From: BRYAN Martin (EXT) [Martin.Bryan.ext@areva.com]
Sent: Wednesday, June 09, 2010 5:42 PM
To: Tesfaye, Getachew
Cc: DELANO Karen V (AREVA NP INC); ROMINE Judy (AREVA NP INC); BENNETT Kathy A (OFR) (AREVA NP INC); GUCWA Len T (EXT)
Subject: Response to U.S. EPR Design Certification Application RAI No. 368, FSAR Ch 6, Supplement 1, Part 2 of 5
Attachments: RAI 368 Supplement 1 US EPR DC Part 2 of 5.pdf

Question 06.02.01-77:

Figure 06.02.01-77-1—Vapor Flow from the Equipment Area to the Containment Dome via the Rupture and Convection Foils

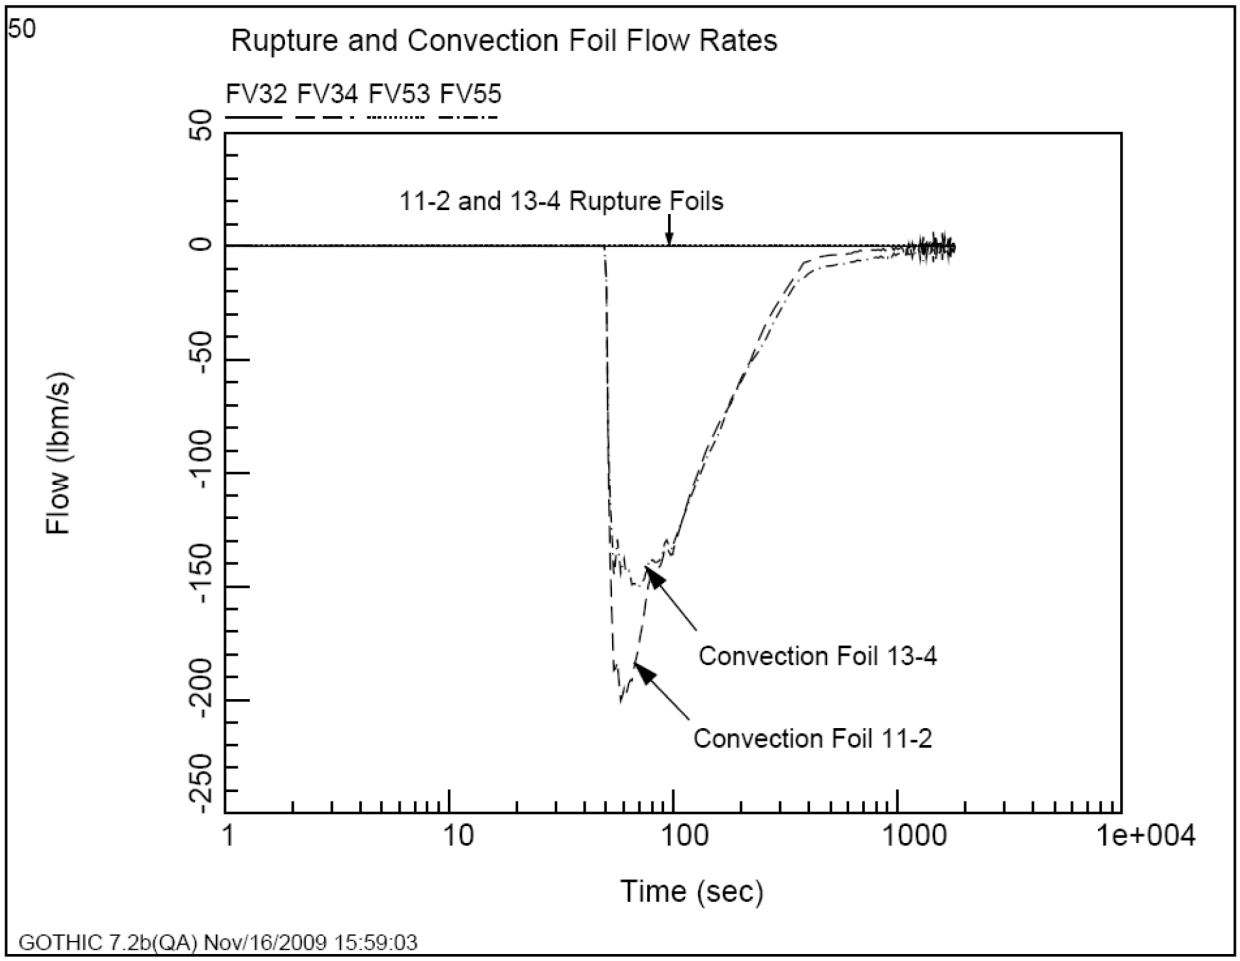
Provide detailed results of one of the DEG MSLB calculations in the accessible area. The results should include: pressure and temperature history, flow rates in various flow path, heat transfer to major heat sinks, concentration of non-condensable gases at selected locations. Discuss observed flow patterns, non-condensable distributions, temperature stratification, local heat transfer and energy deposition to major heat sinks.

The plots in this response, Figure 06.02.01-77-1 through Figure 06.02.01-77-205, are from a double-ended guillotine (DEG) main steam line break (MSLB) analysis at 20 percent power with the break in the accessible area, and not crediting emergency feedwater (EFW). The patterns of flow circulation can be seen in Figures 06.02.01-77-1 through Figure 06.02.01-77-41. Initially, there is no flow in the equipment area of the containment. Once the in-containment refueling water storage tank (IRWST) dampers to the lower annulus rooms open 18 seconds into the transient, a spike in flow rates from the accessible areas to the equipment areas occurs. Following the rapid mass transfer from the accessible areas to equipment areas, the flow circulation reaches a steady-state condition. Figure 06.02.01-77-42 shows the flow circulation patterns during the blowdown.
